# **RESPONSES TO COMMENTS** on the **Draft Environmental Impact Report**

## Central SoMa Plan

PLANNING DEPARTMENT  
CASE NO. **2011.1356E**

DATE: March 28, 2018  
TO: Members of the Planning Commission and Interested Parties  
FROM: Elizabeth White, EIR Coordinator  
Re: **Attached Responses to Comments on Draft Environmental Impact Report:  
Case No. 2011.1356E for the Central SoMa Plan**

**Figure RTC-1**  
Existing, Proposed, and Revised Height and Bulk Map for Block 3762

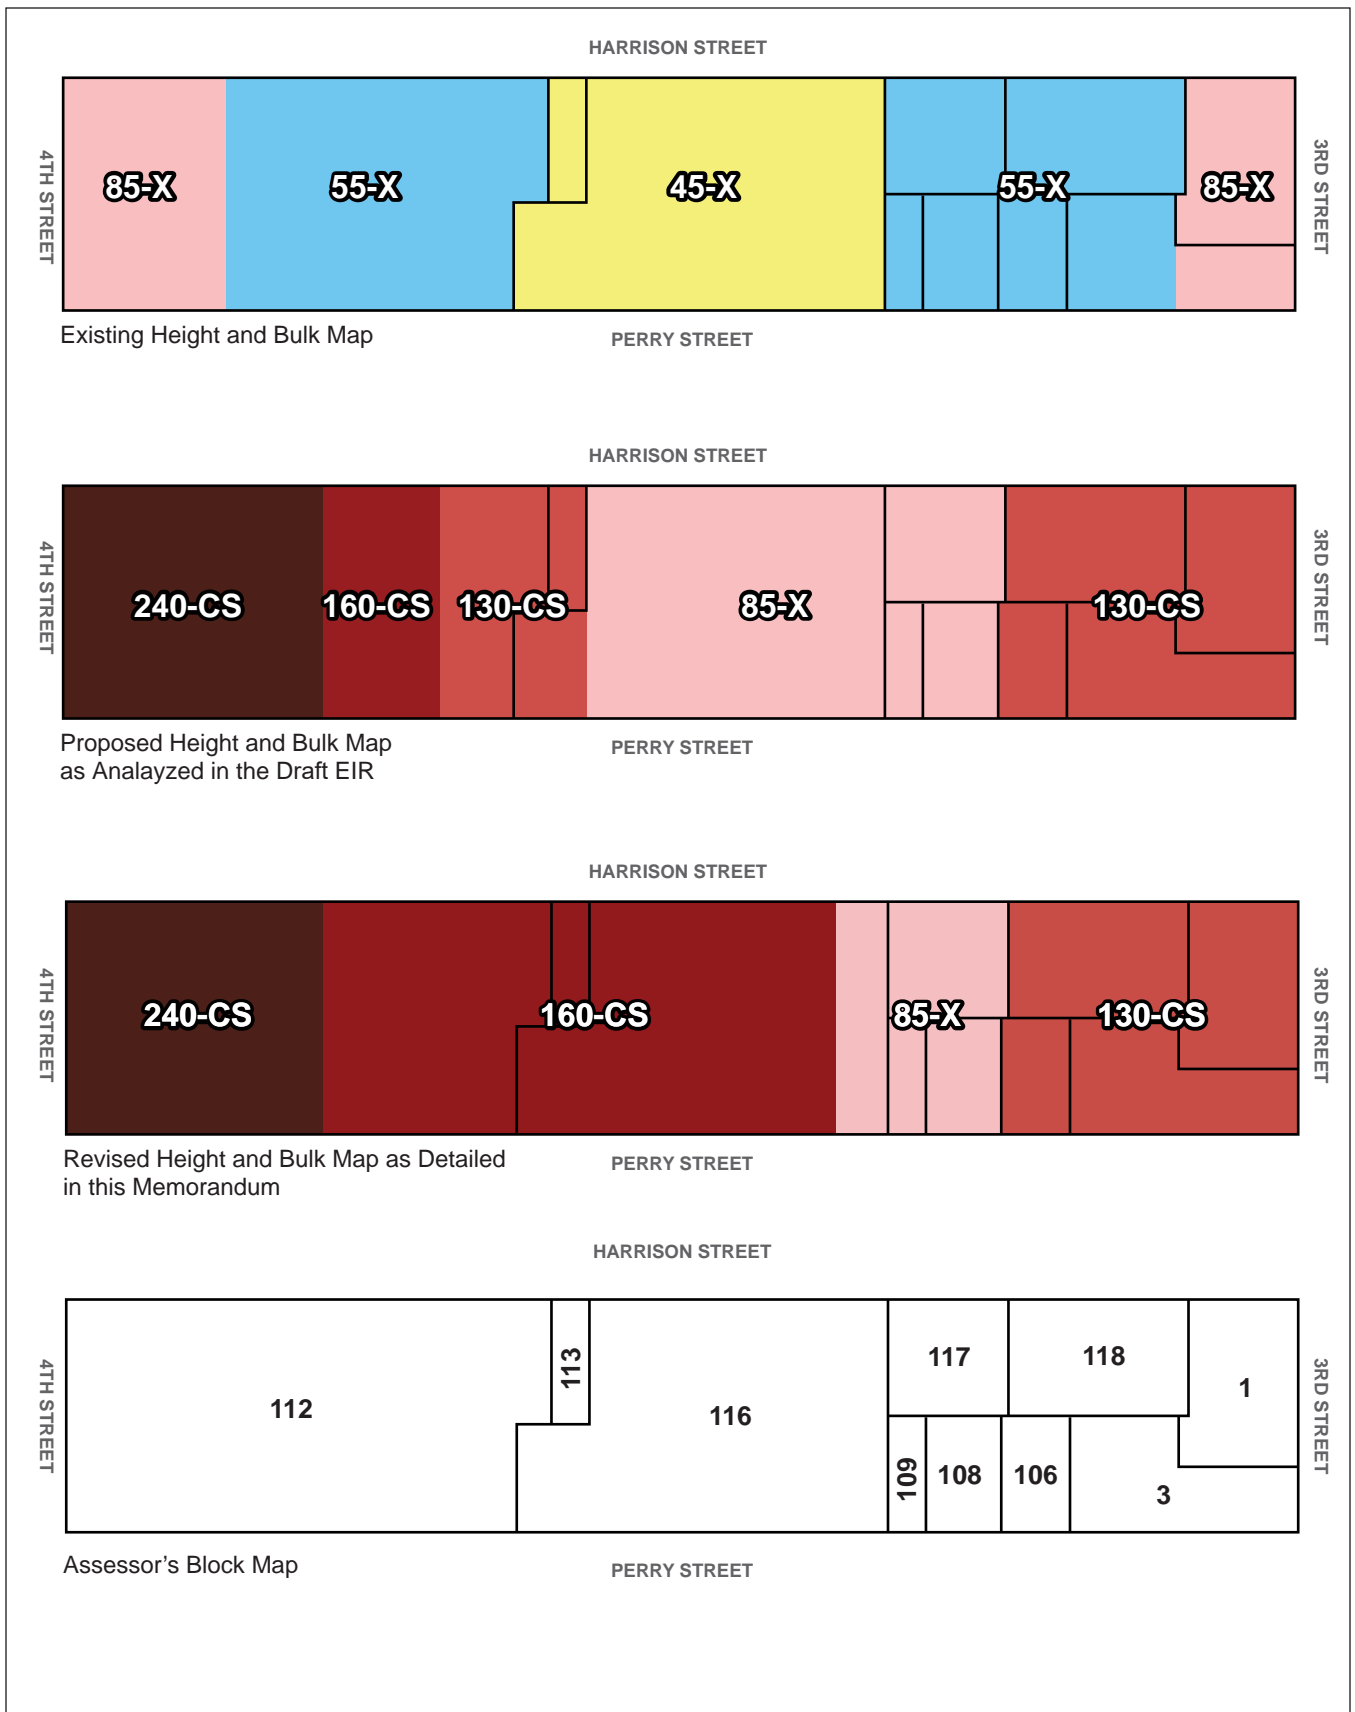
The Planning Department proposes to alter the proposed Height and Bulk Map from that analyzed in the Draft EIR for a portion of the block bounded by Harrison, Third, Bryant, and Fourth streets.<sup>4</sup> Specifically, the proposal entails extending a 160-CS Height and Bulk District to encompass most of the mid-block area including the eastern half of Lot 112 and all of Lots 113 and 116 within Block 3762. The Draft EIR evaluated the western portion of this mid-block change as a 130-CS Height and Bulk District and the eastern portion as an 85-X Height and Bulk District. See **Figure RTC-1, Existing, Proposed, and Revised Height and Bulk Map for Block 3762**, which depicts the existing height of the block, the proposed heights analyzed in the Draft EIR, and the revised heights now proposed. Draft EIR **Figure II-7, Proposed Plan Area Height and Bulk Districts [Revised]**, and **Figure II-8, Generalized Height Limits, Existing and Proposed Height and Bulk Districts [Revised]**, are also revised to show the changes.

Based on the foregoing, the revisions to the Draft EIR Height and Bulk Map (Draft EIR Figure II-7, p. II-19) would not result in any new or substantially more-severe significant aesthetic impacts than identified in the Draft EIR.

**Figure RTC-2**  
Wind Tunnel Test Points Near Block 3762

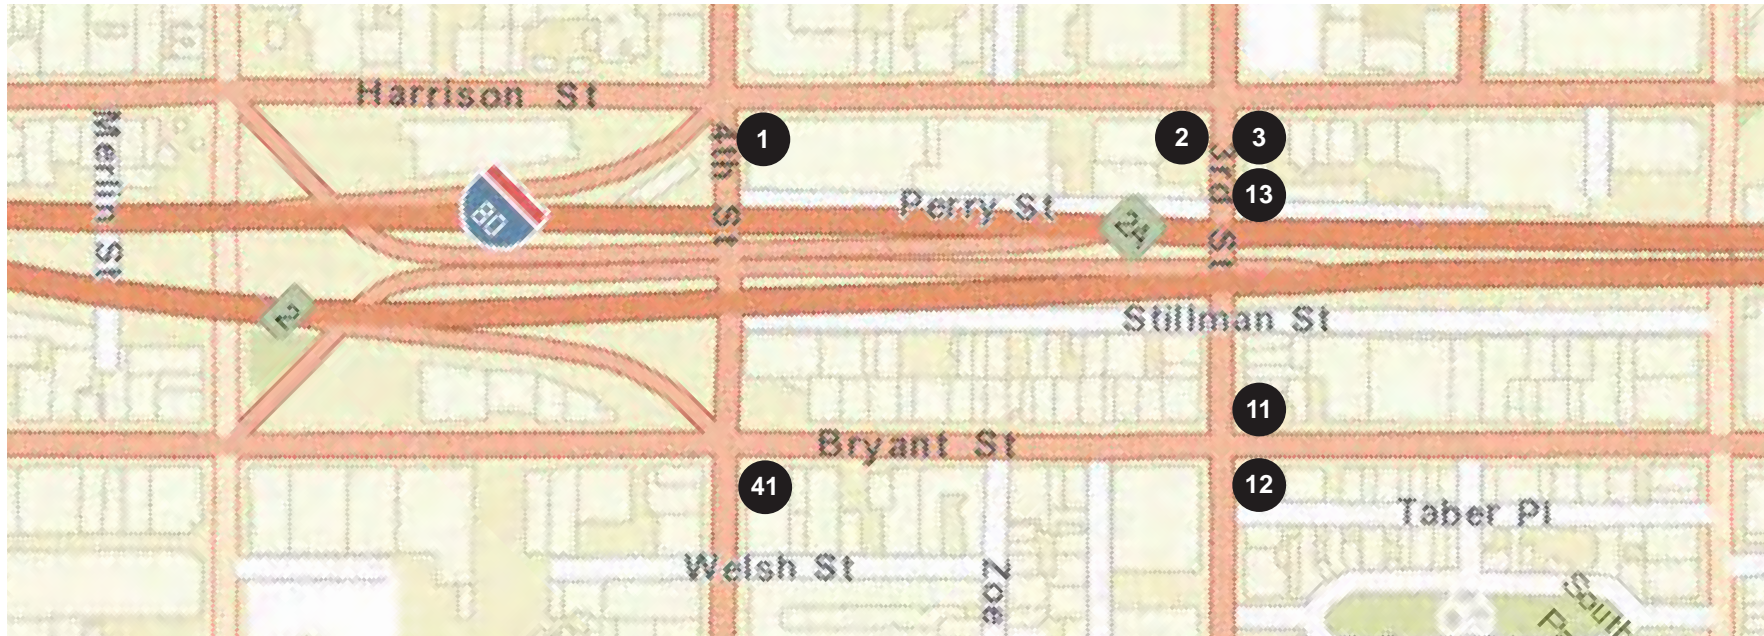
Programmatic wind-tunnel testing for the Draft EIR was undertaken at the Plan level, based on the same building masses as evaluated in the visual simulations, including the revised simulations presented in this RTC document.<sup>7</sup> In the vicinity of the proposed changes to the Height and Bulk Map, wind test points were located at the following seven locations<sup>8</sup> (see **Figure RTC-2, Wind Tunnel Test Points near Block 3762**):

No test points were immediately adjacent to the Harrison Street frontage where the Height and Bulk Map changes are proposed; the closest points are those at Fourth and Harrison and at Third and Harrison streets. Existing conditions at the seven test points noted above are moderately windy, with the wind speed that is exceeded 10 percent of the time, or wind comfort speed, ranging from 6 miles per hour (mph) to 19 mph.<sup>9</sup> (In general, conditions in SoMa are less windy than in very windy locations in San Francisco, such as the Van Ness and Market area.) Of the seven test points, the Draft EIR wind-tunnel testing found that Plan Area development would alter the wind comfort speed by 1 to 5 mph. Wind speed would decrease at five of the seven points and would increase at two locations—the southwest and southeast corners of Third and Harrison streets—by 3 mph. Wind speeds do not currently exceed the Planning Code's hazard criterion of 26 mph for one full hour of the year at any of the seven locations under existing conditions and would not do so under conditions with Plan development.

Based on the foregoing, the revisions to the Draft EIR Height and Bulk Map (Draft EIR Figure II-7, p. II-19) would not result in any new or substantially more-severe significant wind impacts than identified in the Draft EIR.

Case No. 2011.1356E: Central SoMa Plan  
**Figure RTC-4**  
 Revision to Plan Area Boundaries

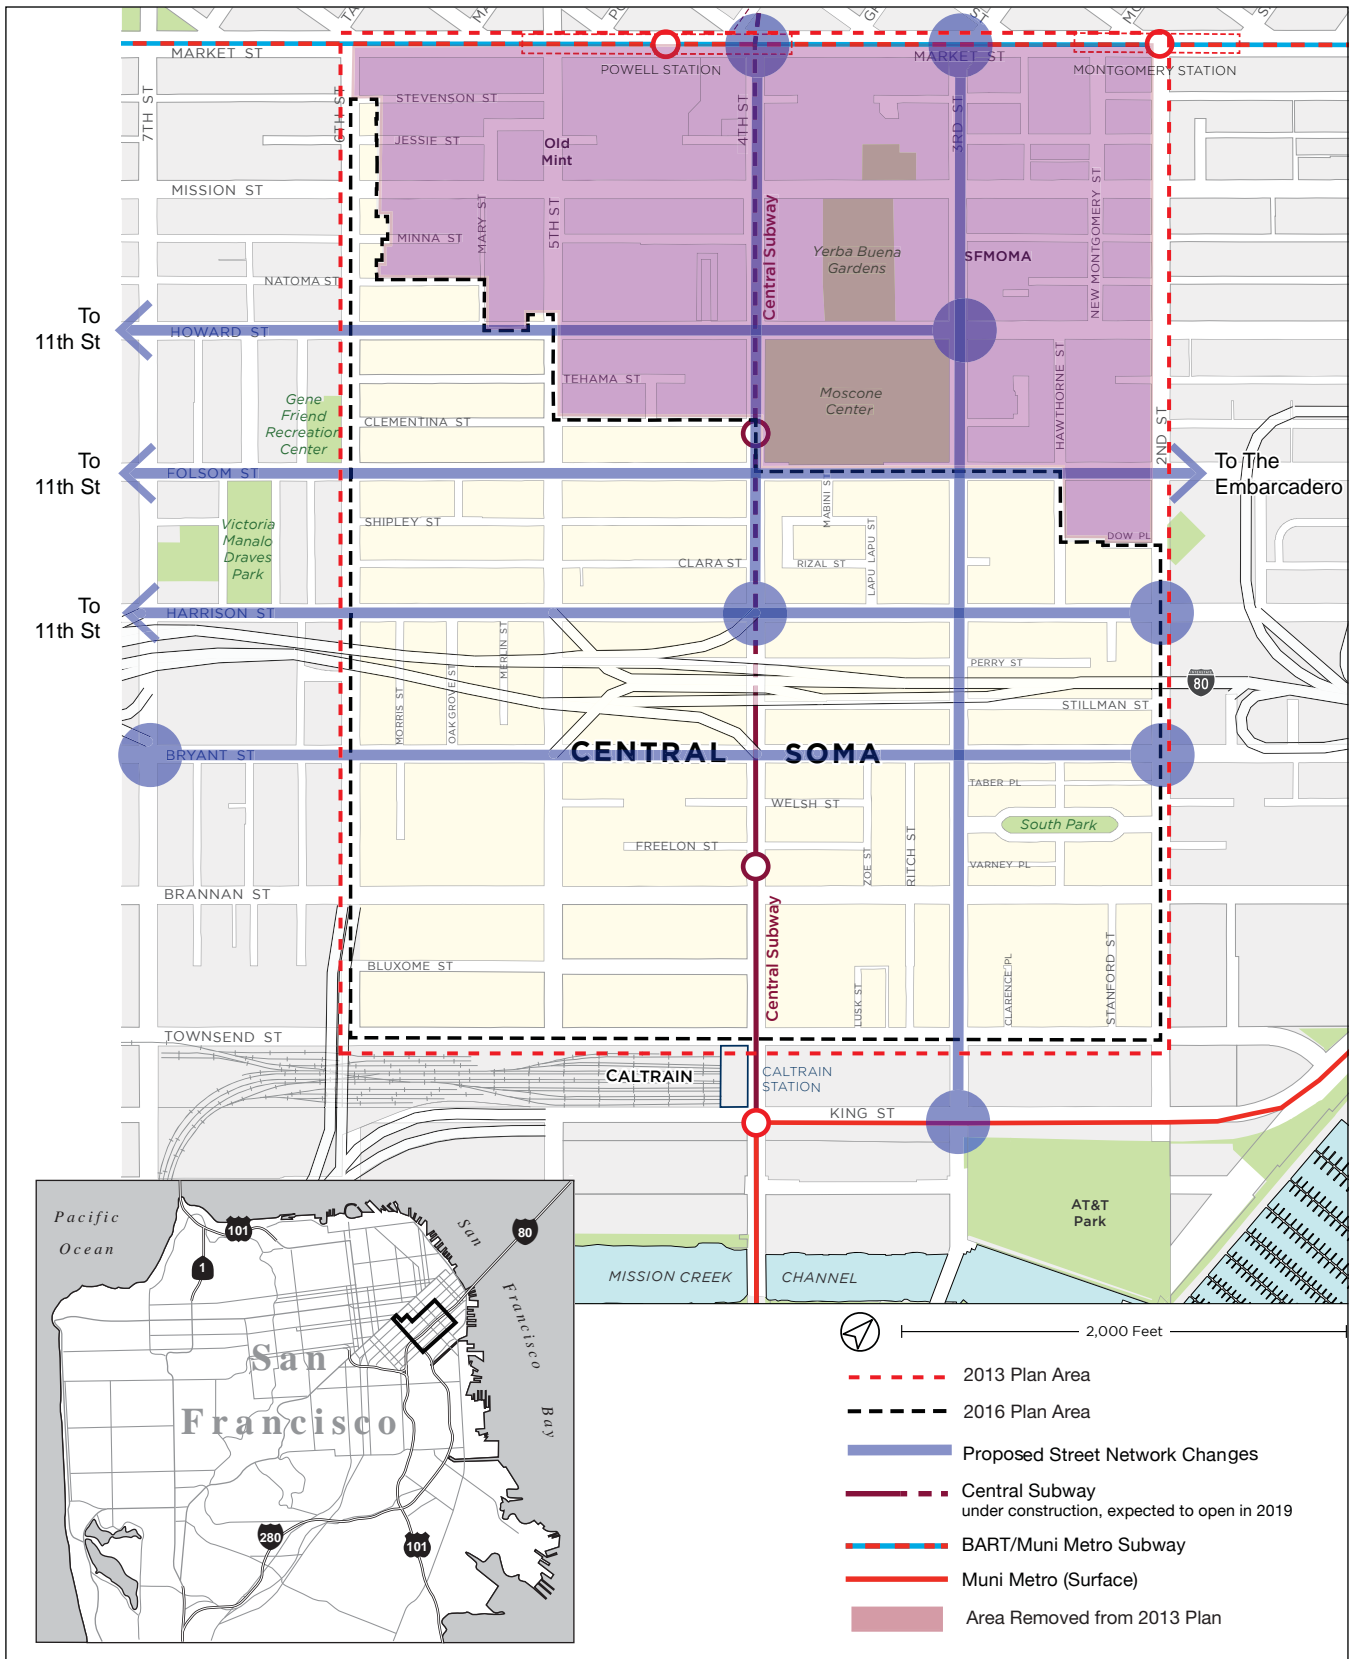
Under the 2013 Plan, none of the parcels outside of the Eastern Neighborhoods Plan Area were proposed for rezoning to a different use district, with the exception of the RC-4 parcel, occupied by three affordable housing buildings owned and operated by TODCO and the Tenderloin Neighborhood Development Corporation, which was proposed for rezoning to C-3-S (Downtown Commercial Support) for consistency with the surrounding area. However, this zoning revision was not anticipated to result in any physical change or change in use, given that TODCO's mission is the provision of affordable housing and enhancing socioeconomic conditions for the poor, disadvantaged, and working-class people in SoMa. Moreover, should this site be sold in the future, the regulatory constraints to removal or demolition of affordable residential units in San Francisco would limit potential changes. Moreover, no changes in height limits were proposed under the 2013 Plan on any of the parcels now no longer within the 2016 Plan Area, save for a *decrease* in height limit that had been proposed on the blocks occupied by the Moscone Convention Center. Accordingly, while the Initial Study analyzed physical effects of development subsequent to the Plan in the approximately 30-acre area that is no longer included in the 2016 Plan, the 2013 Plan would not have substantially increased the foreseeable amount of development in this area because the 2013 Plan did not propose changes to use districts or height limits that would have the potential to increase the projected amount of development and this development could occur pursuant to existing zoning, whether or not the Plan is adopted. It is for these reasons that the Plan Area boundaries were modified in the 2016 Plan. The adoption of the 2013 Plan would not have facilitated any additional development that could not already occur on the parcels removed from the Plan Area (see **Figure RTC-4, Revision to Plan Area Boundaries**, p. RTC-67).

In light of the foregoing, the geographical change in the Plan Area between publication of the Initial Study and publication of the Draft EIR does not result in any inadequacy in either document, does not set forth substantial new information, and does not require recirculation of either the Initial Study or the Draft EIR.
